STATE OF MARYLAND

December 4, 2020

Re: Mattawoman Energy, LLC – Request for Modification of Mattawoman Energy Center
CPCN, PSC Case No. 9330

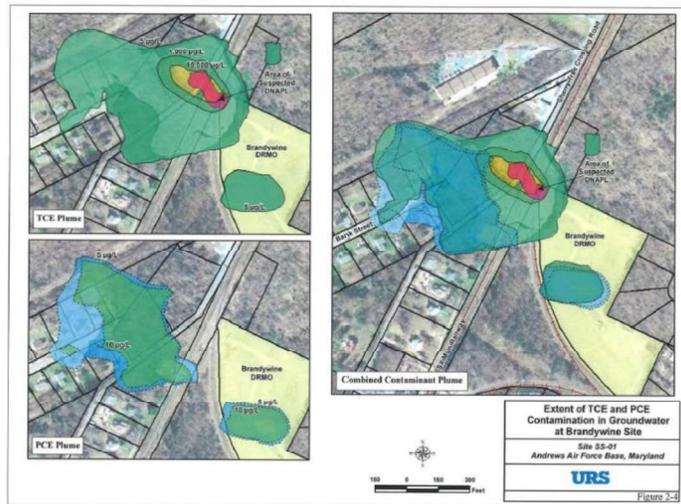
Section 2.4 - Potential impacts to ground water quality from the Joint Base Andrews Superfund site are not properly considered. *The PSC should require that the Request for Amendment be amended to clearly identify the lateral extent of the contaminant plume from the Superfund site at Joint Base Andrews, and to reassess the potential impact of the drawdown based on this new information.*

Response – Per a letter from the Department of the Air Force Headquarters Air Force Legal Operations Agency dated October 14, 2020, Joint Base Andrews (JBA) does not oppose Mattawoman’s current request for amendment to its CPCN. Review of the contamination in ground water maps prepared for the JBA Brandywine Site indicate the chlorinated solvent plumes are located in the northwest region of the site and extend in a westerly direction (see insert). Based on these maps the area of predicted drawdown is more than 2,000 feet from the nearest edge of the contaminant plume and will not impact the remediation efforts.

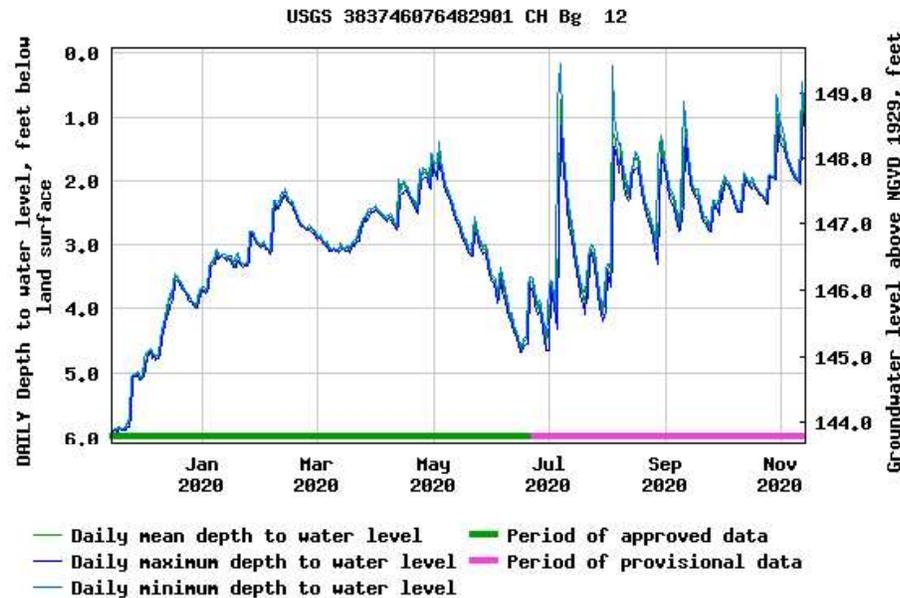
Section 4.1 - Cumulative impacts to streams and wetlands from dewatering are not fully considered. *The PSC should require that the Request for Amendment be amended to clearly identify the total linear feet of streams which will be impacted by dewatering in each construction segment and for the Mattawoman Creek and Zekiah Swamp watersheds.*

Response – As displayed in the graph provided for the USGS water table well CH Bg 12², the ground water table depth can fluctuate nearly 6 feet over the course of a year. Thus, the reduction

in water table due to dewatering in this localized area will not result in a measureable impact to the upper reaches of Mattawoman Creek, Wolf Den Branch nor Zekiah Swamp. Furthermore, Mattawoman has indicated that the removed water will be filtered and returned into existing nearby stormwater drainage swales, ditches, and/or ponds that are in close proximity to the area of dewatering, and thus will more quickly recharge the areas where water is withdrawn. Also as stated in response to 3.1, we are recommending that water removed is returned back to the watershed from which it is withdrawn.
